CITY OF ST. HELENS PLANNING DEPARTMENT

MEMORANDUM

TO: Planning Commission acting as the Historic Landmarks Commission
FROM: Jacob A. Graichen, AICP, City Planner
RE: 71 Cowlitz Street (The Klondike Tavern) Architectural Review
DATE: May 5, 2026

ARCHITECTURAL
 SITE PLAN

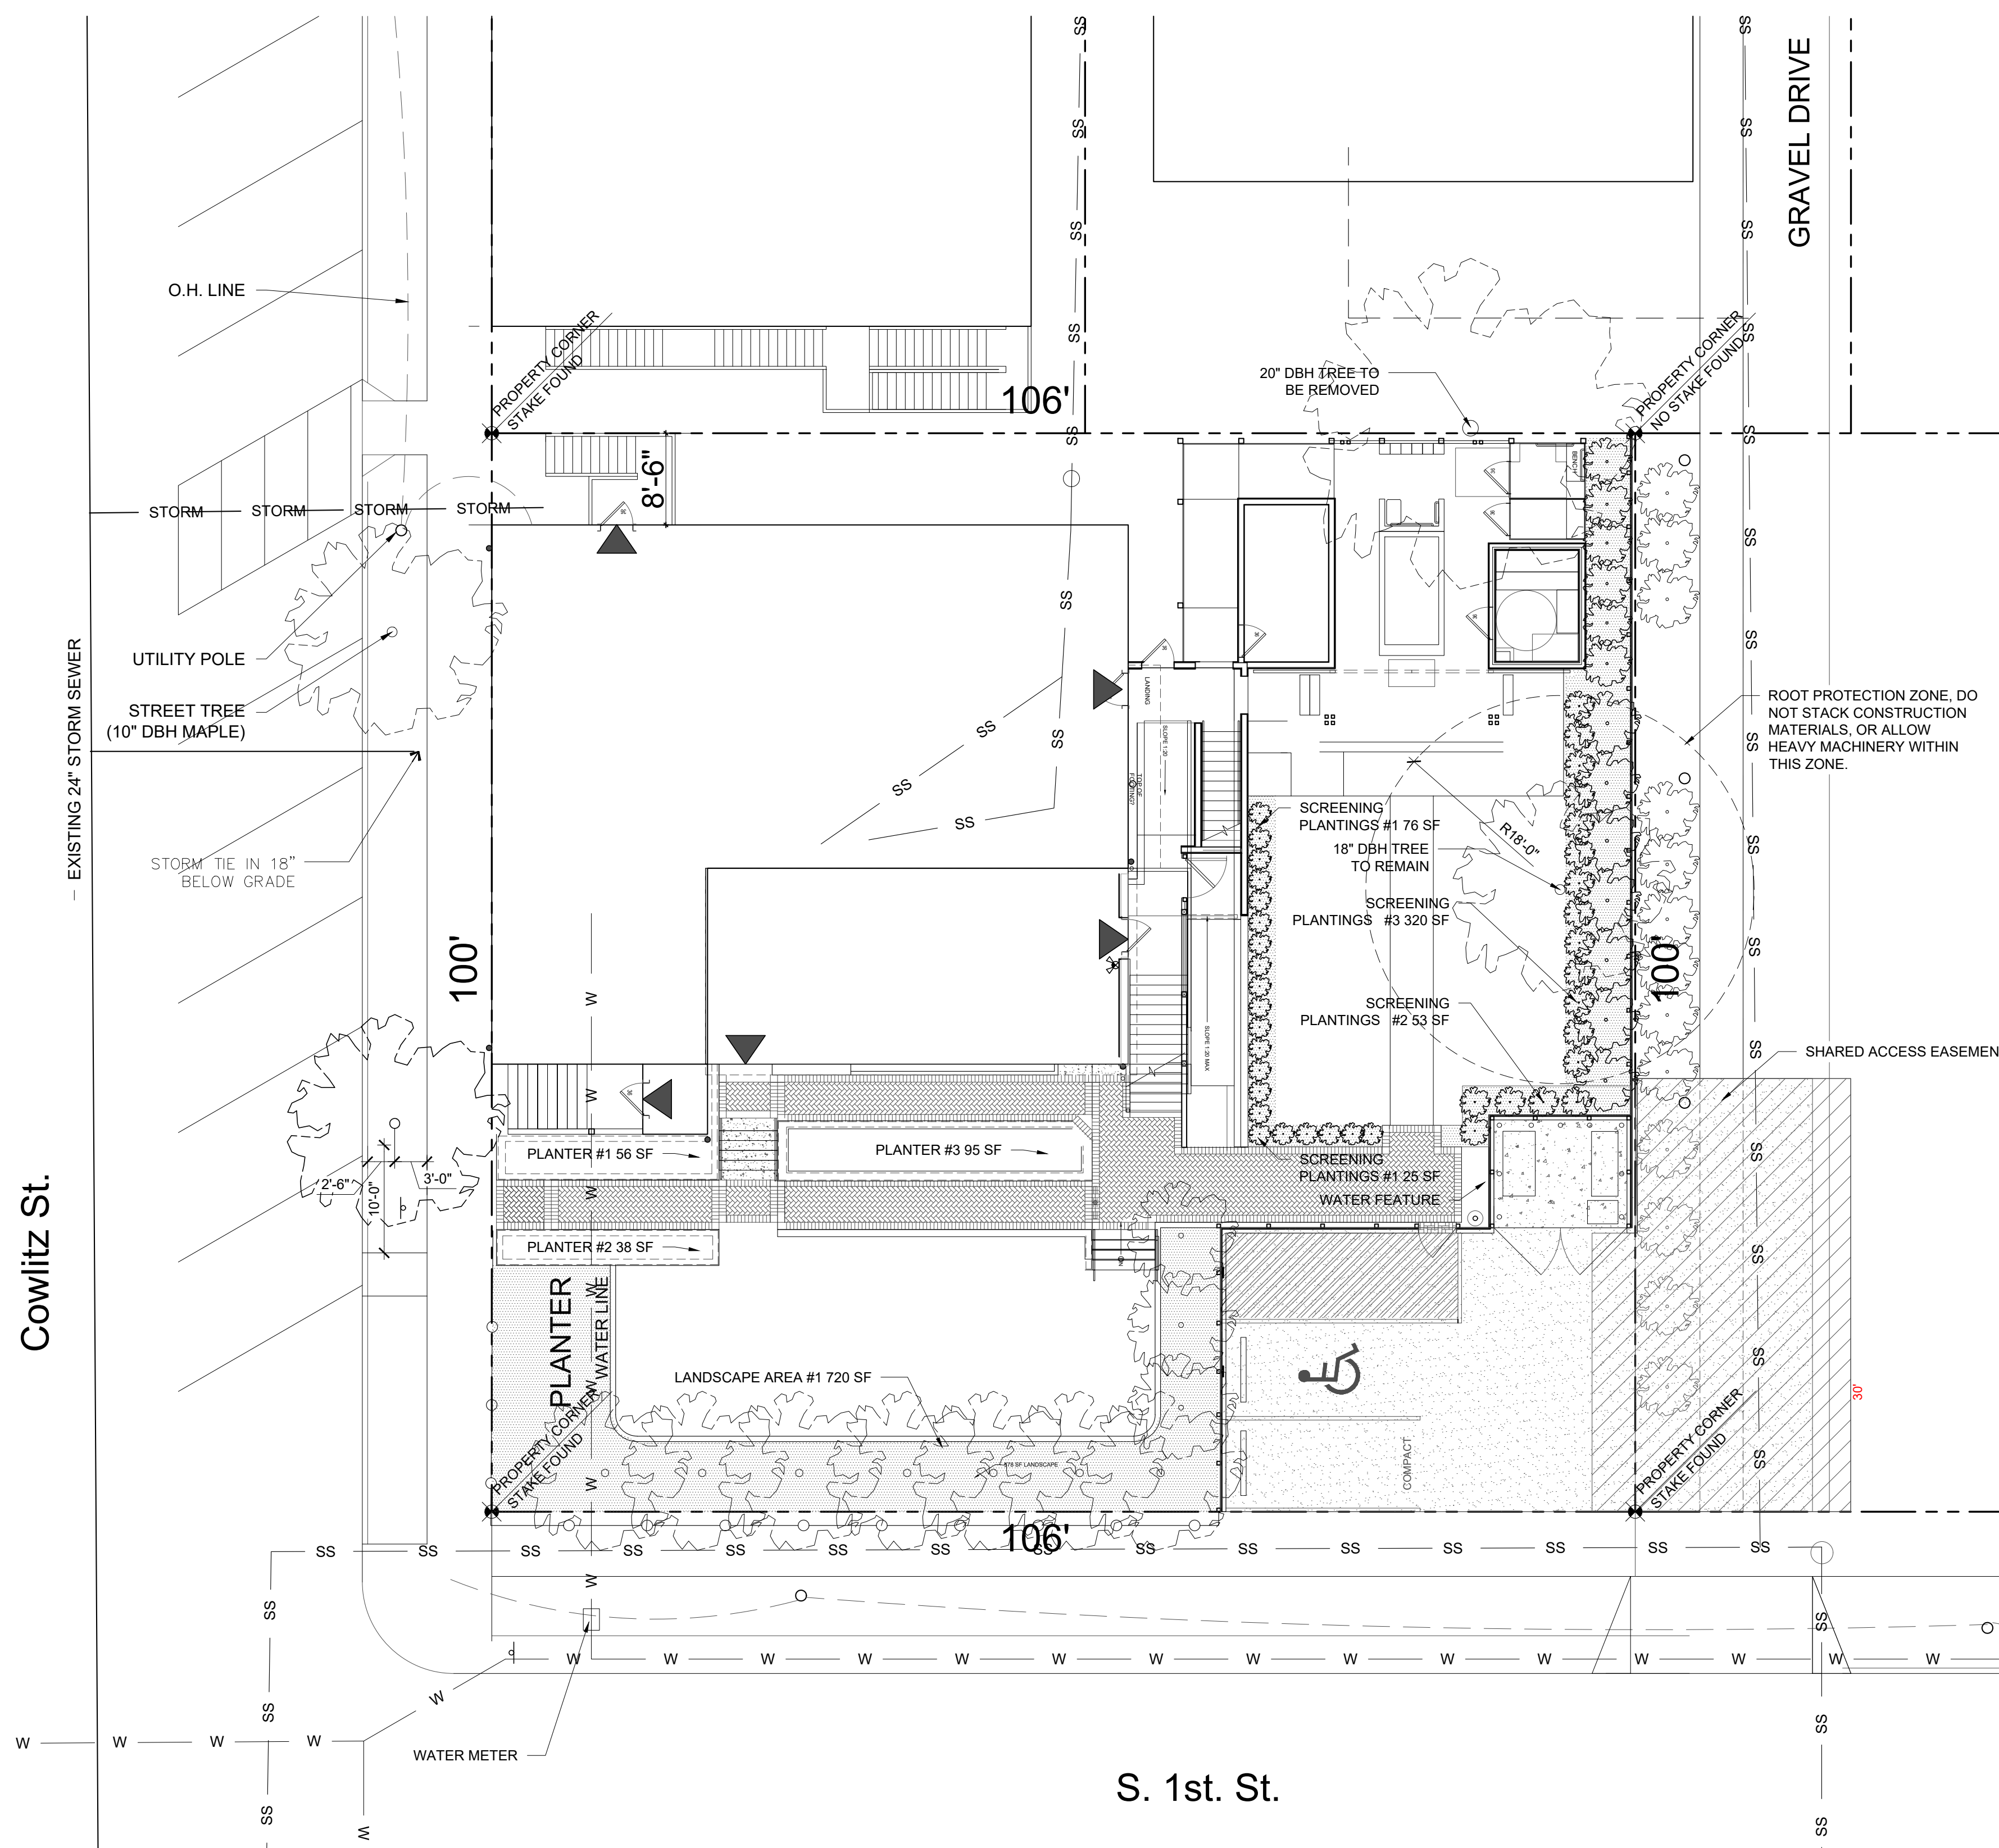
There is no information about the door at the improved east side entry. As it will be obscured by the covered entryway, does the Commission have any concern about this?

The Guidelines note to not use balconies that are not original to the structure. The new covered entry has an integrated balcony as part of the roof structure, so it's not just a balcony. Is the Commission ok with this?

The pavilion (new structure) will have CMU, mostly on the back (east) side, which will not be as visible with some galvanized corrugated metal on the front, but only towards the bottom. These materials may not be traditional, but they are not front and center. That said, is the Commission ok with this?

Note that fiberboard is proposed for the walls of the new eastside entry. This is probably because that additional will be at the property line where the building code typically requires fire rated construction.
